Project Number: SP2018-002
Project Name: Interstate Wire Company
Project Type: SITE PLAN
Applicant Name: DB CONSTRUCTORS INC
Owner Name: ROCKWALL ECONOMIC DEVELOPMENT
Project Description:

City of Rockwall Project Plan Review History

AGENDA ITEM: **SP2018-002**; Site Plan for *Interstate Wire Co., Inc.*

RE: SITE PLAN (SP2018-002), Interstate Wire Company

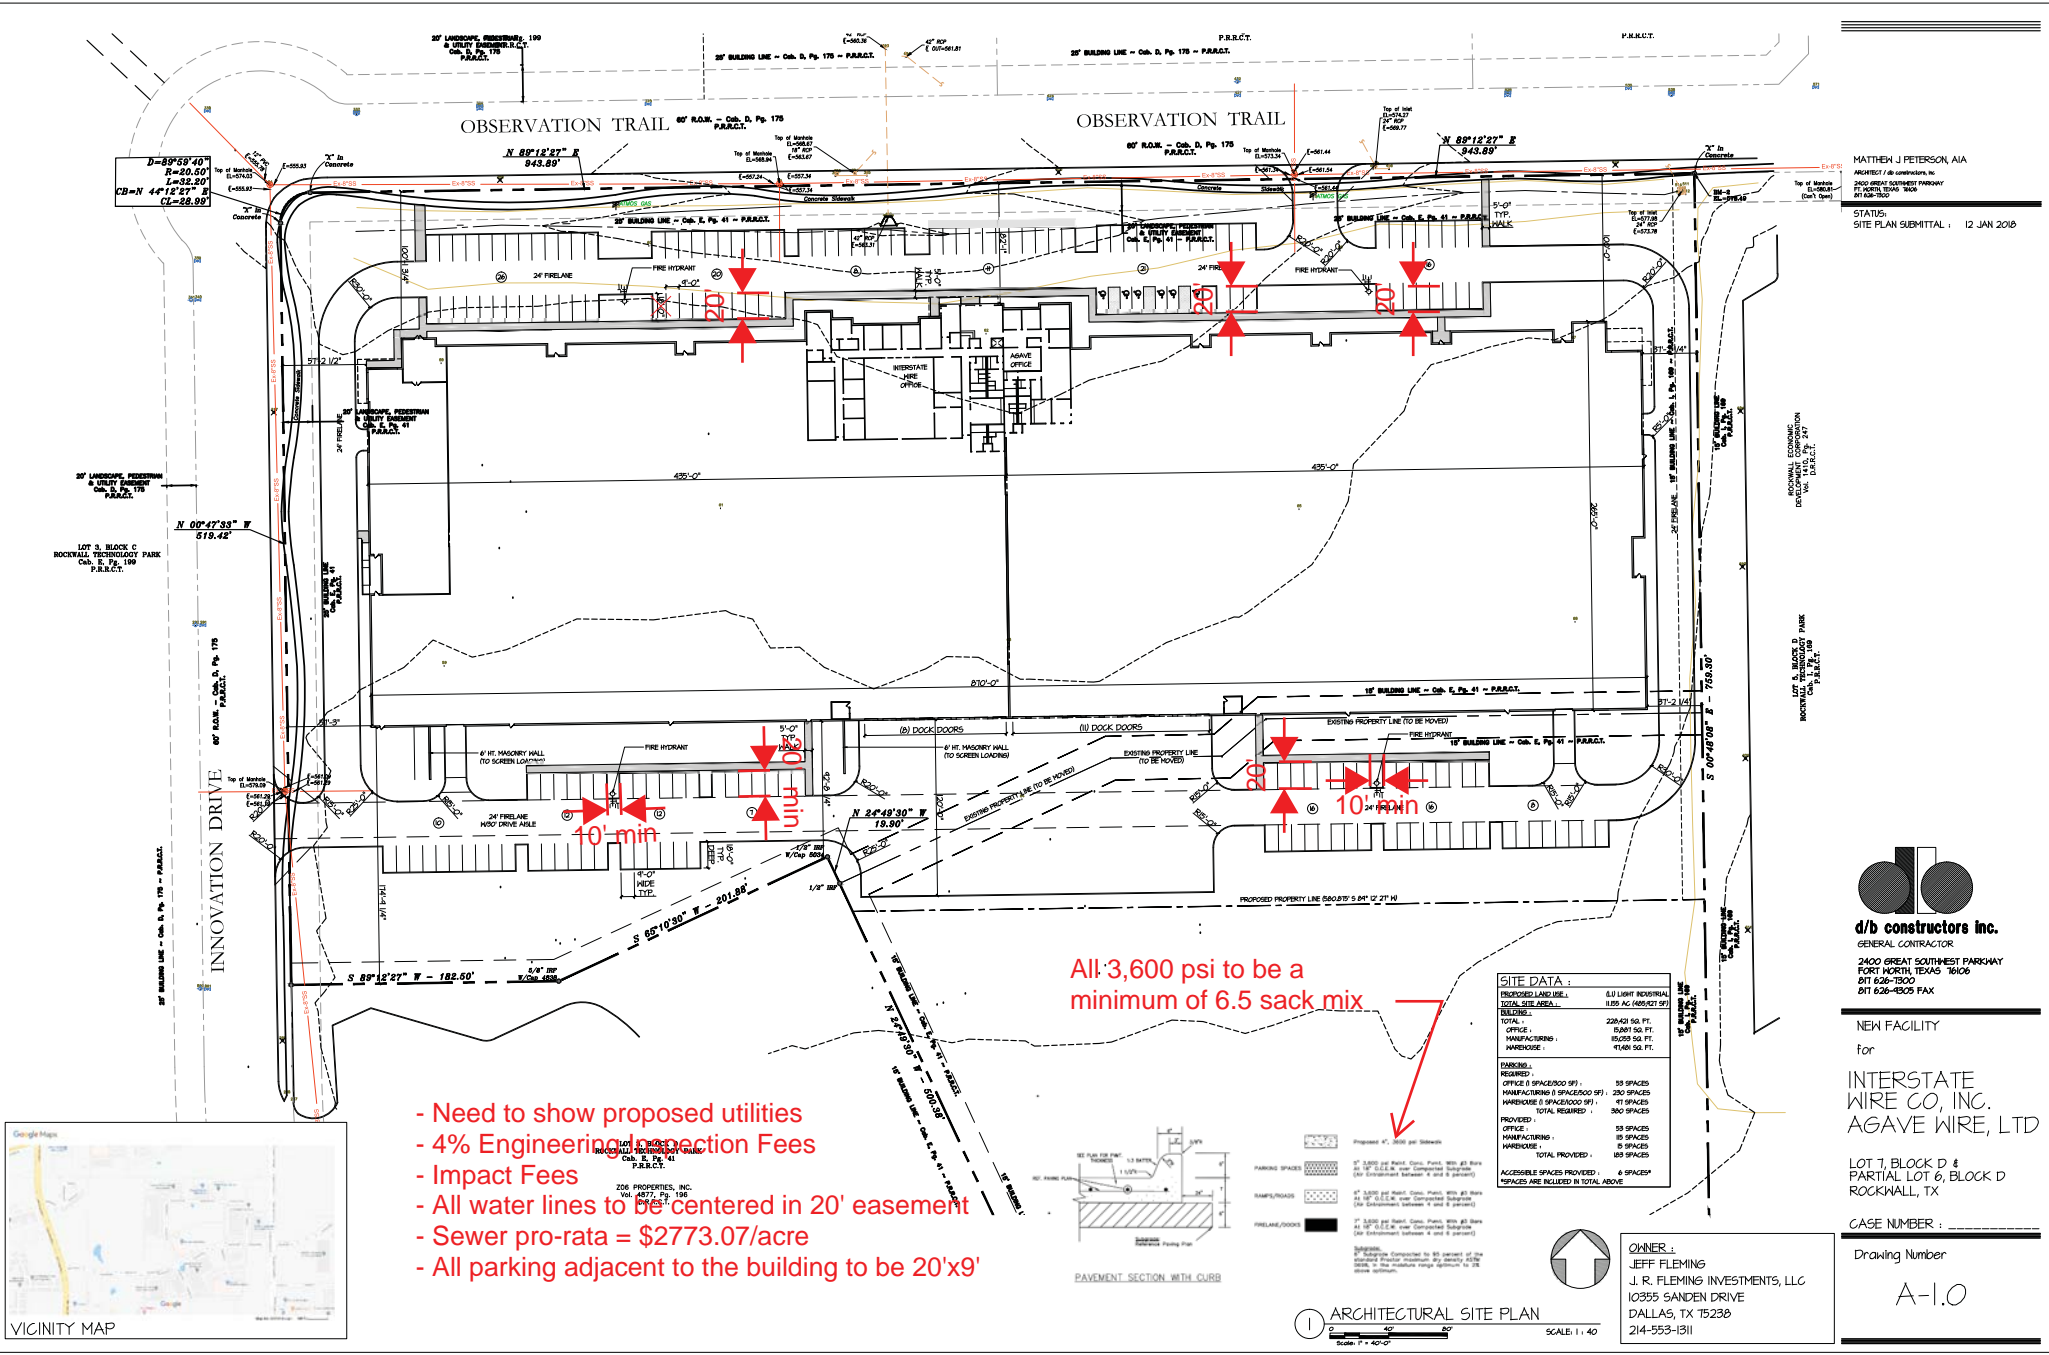
1. Per Sec. 1.5.2, of Article V, of the UDC, The access area of all refuse storage areas for trash dumpsters shall be screened with an opaque gate and shall not face a public street unless otherwise approved during site plan approval process.

a. Where is the trash dumpster enclosure located? Will this exception be requested?

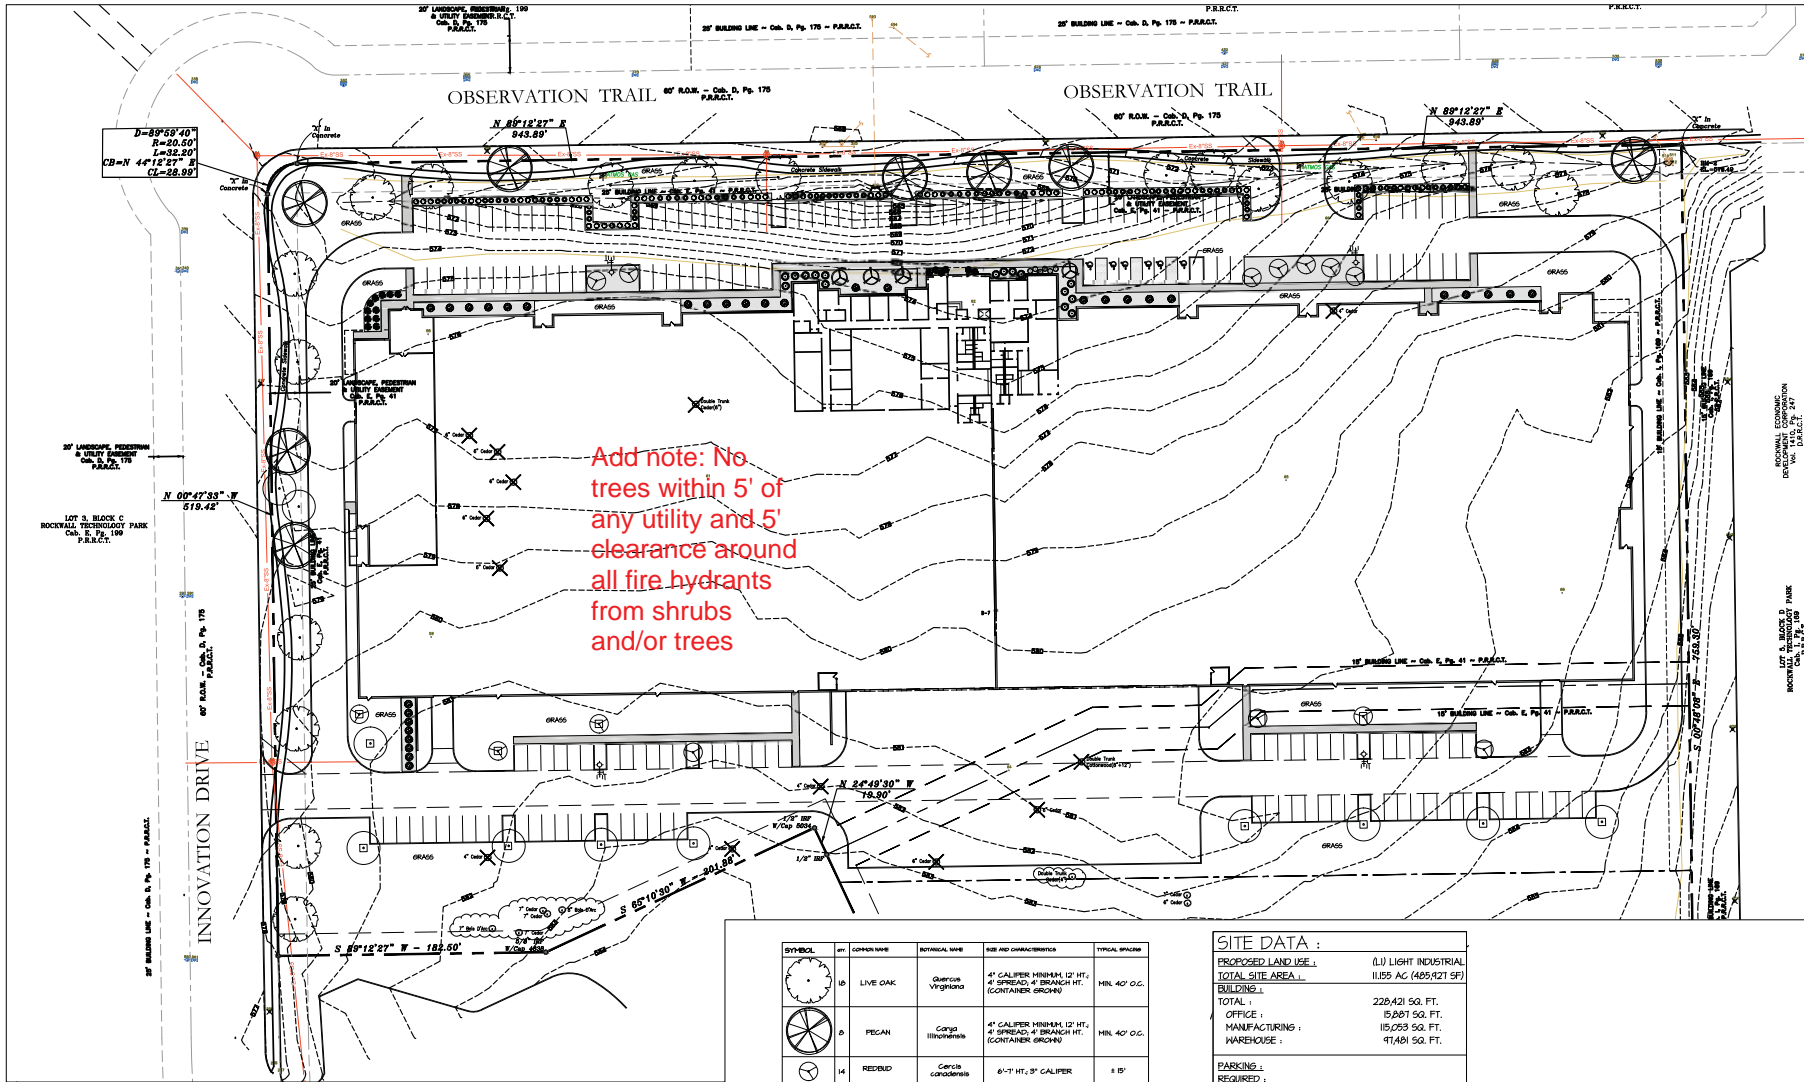
- Need to show proposed utilities
- 4% Engineering Inspection Fees
- Impact Fees
- All water lines to be centered in 20' easement
- Sewer pro-rata = \$2773.07/acre
- All parking adjacent to the building to be 20'x9'

All 3,600 psi to be a minimum of 6.5 sack mix

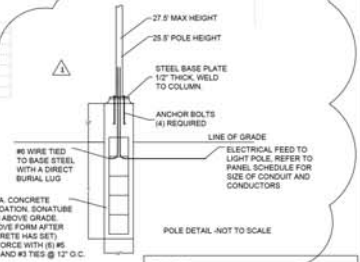
PROVIDE POLE DETAIL

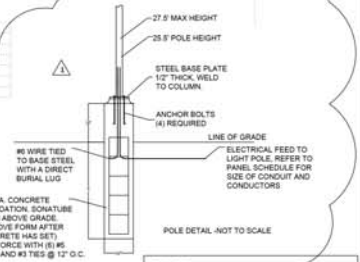
PROVIDE POLE DETAIL
